TAFF REPORT: 05/08/2024 MEETING

APPLICATION NUMBER: HDC20204-00182

ADDRESS: 1485 LONGFELLOW

SCOPE OF WORK: ERECT REAR ADDITION

1485 Longfellow, current conditions. Facing southwest. Staff photo taken on 4/22/2024

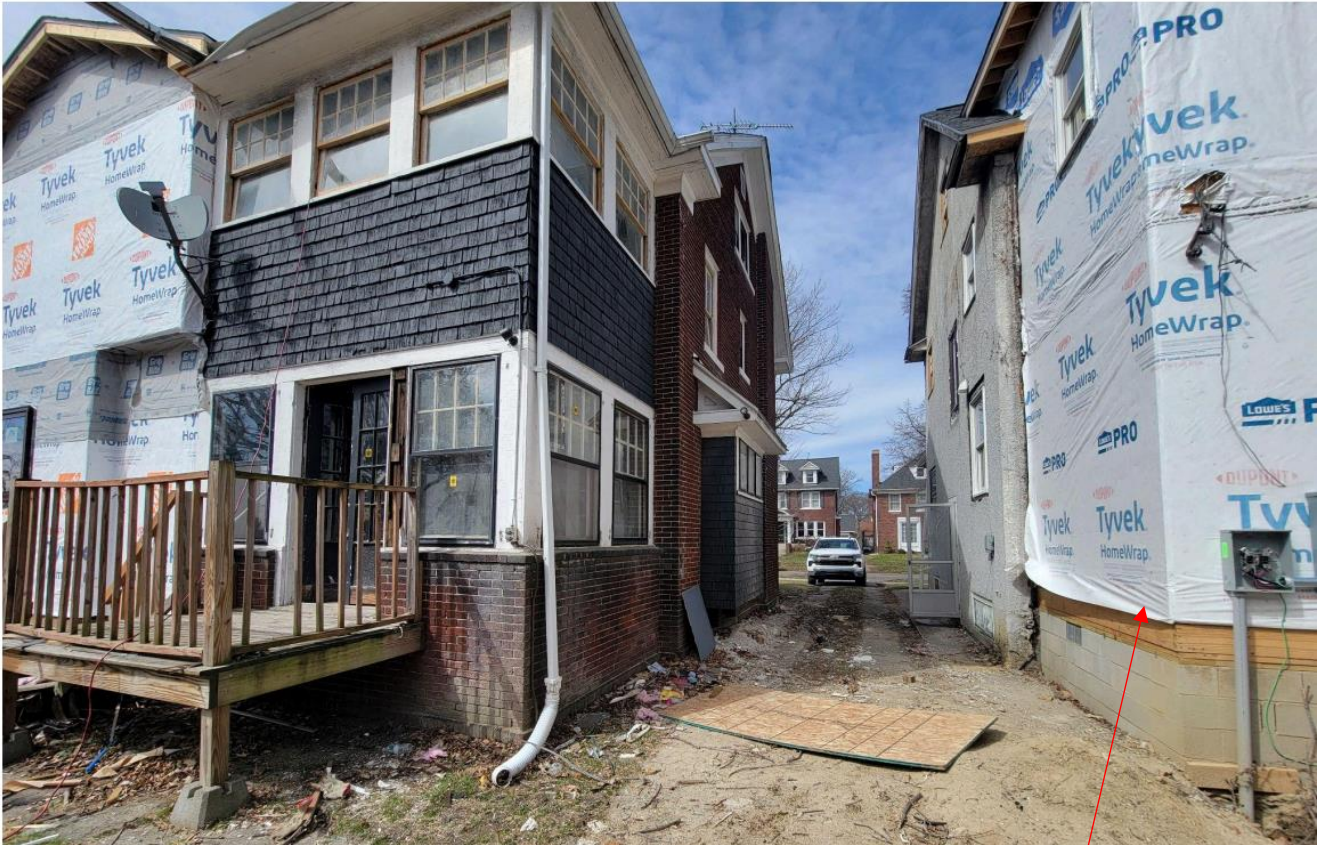
- It is staff's opinion that the newly erected rear wing does not meet the Standards because it has been directly appended to the character-defining, two-story, rear wing resulting in the removal of its entire west wall and completely changing its overall form. Also, the large scale of the addition overpowers/is not subordinate to the significant rear wing.

- It is staff's opinion that the historic-age, paired wood French doors proposed for removal are distinctive character-defining features of the home which should be retained as it is not clear that they are deteriorated beyond repair (see photo on page 6).

Recommendation # 1 - Section 21-2-73, DENIAL – Erect a rear wing and replace existing French doors at rear elevation with salvaged window
